Docket No. 50-346

Serial No. 1065

July 30, 1984

ADDITIONAL INFORMATION TO TOLEDO EDISON'S  
SUBMITTAL CONCERNING ON-SITE DISPOSAL OF RESIN

Figure 1  
Davis-Besse Site Area Map

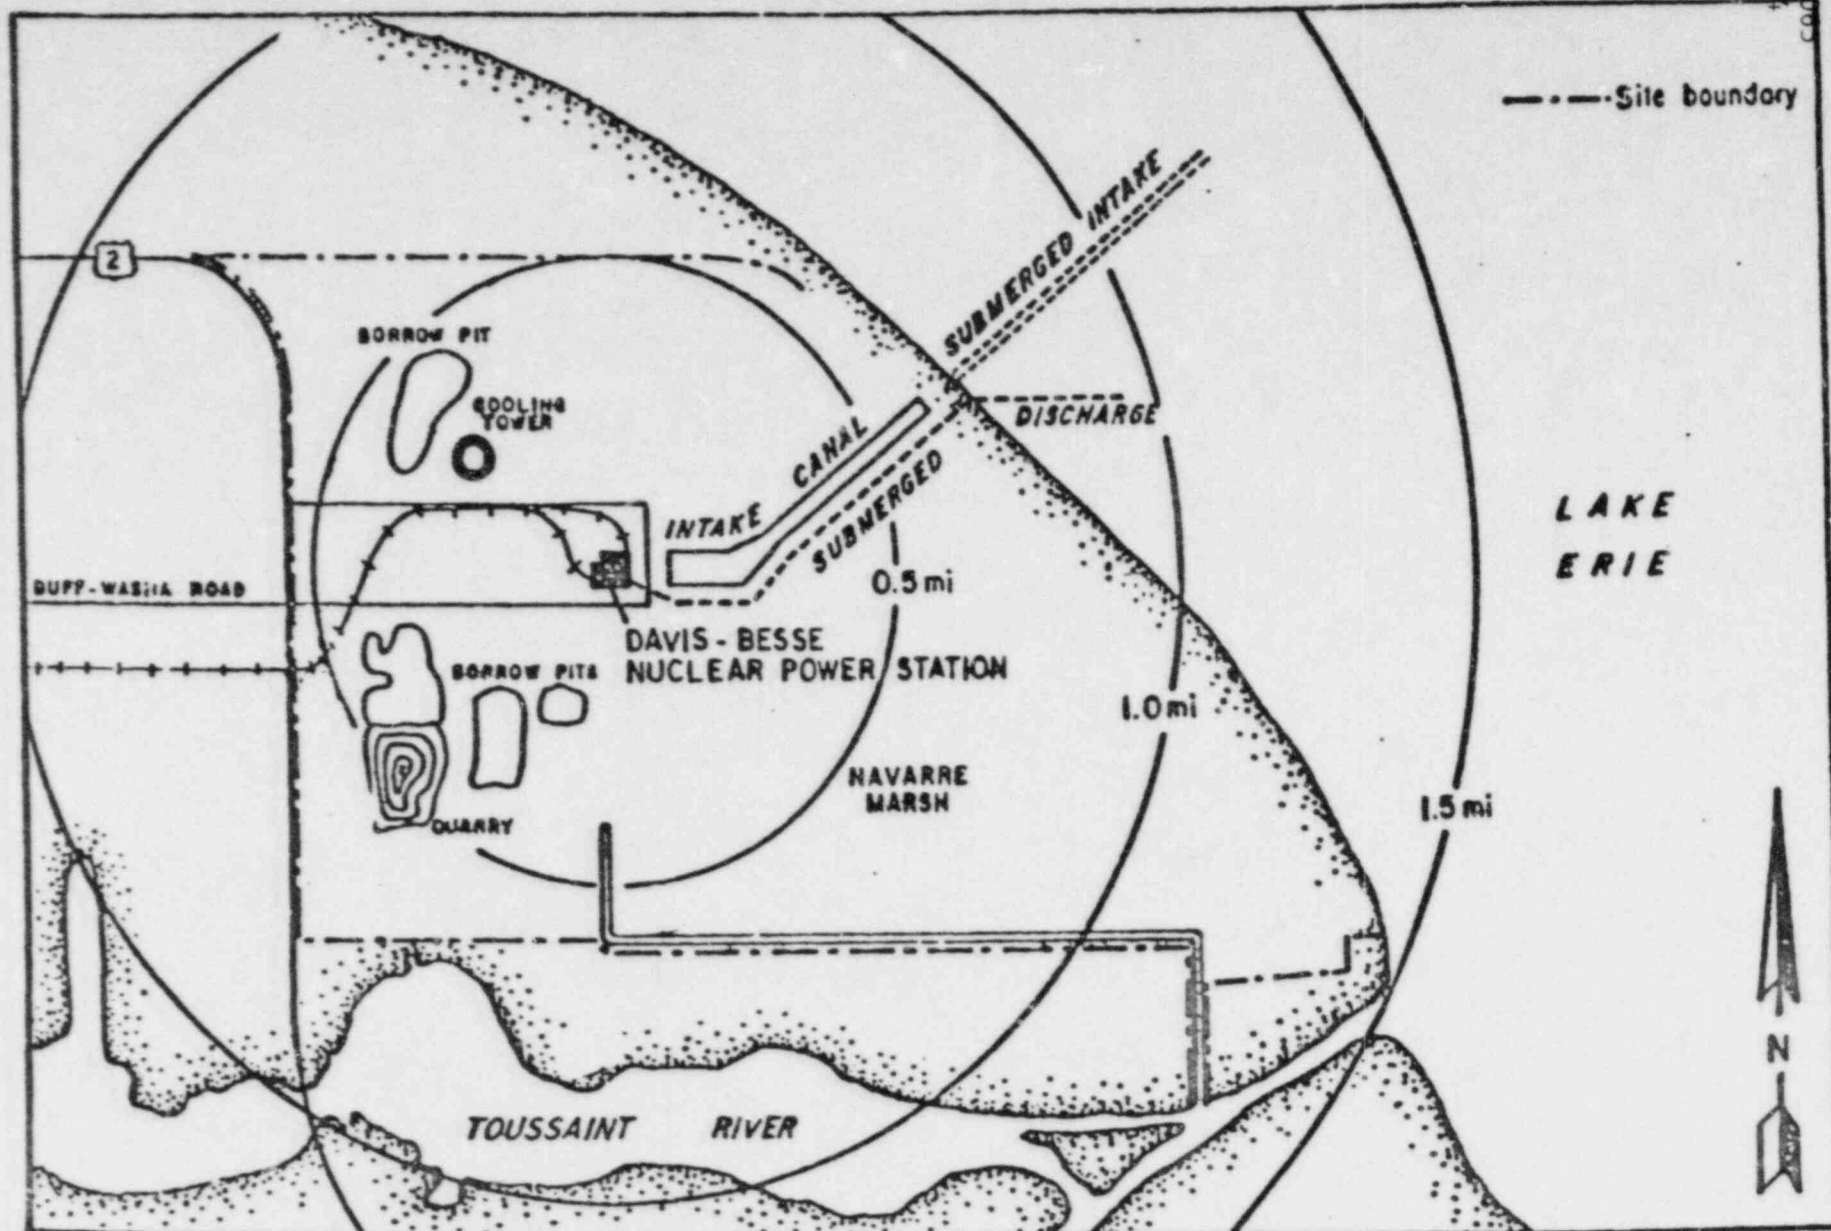
Question 4: Describe the planned disposal site for the dredged material. For the planned on-site disposal, the disposal site description should include (1) a numbered and captioned figure of the disposal site showing its proximity to areas frequently occupied by workers, and to the unrestricted area; (2) the area of the disposal site, and the planned thickness of the disposed material; (3) a description of any physical barriers or administrative procedures that would be used to reduce exposure of workers or the general public; (4) the type of and thickness of any covering material that will be placed over the dredged material to reduce exposure; and (5) the time frame in which any covering will be placed over the dredged material.

Response: While the specific on-site location for the actual disposal of the dredged basin bottoms remains to be identified, the following particulars of the site selection and disposal method are applicable:

- The Davis-Besse site contains approximately 954 acres. There exist numerous on-site locations that are remote from frequently occupied areas and that are acceptable for use as a final disposal area for the dredged basin bottoms. The selected disposal site will be a minimum of 100 yards from any area frequently occupied, either on-site or off-site. The attached site area map (Figure 1) indicates the general characteristics of the Davis-Besse site.
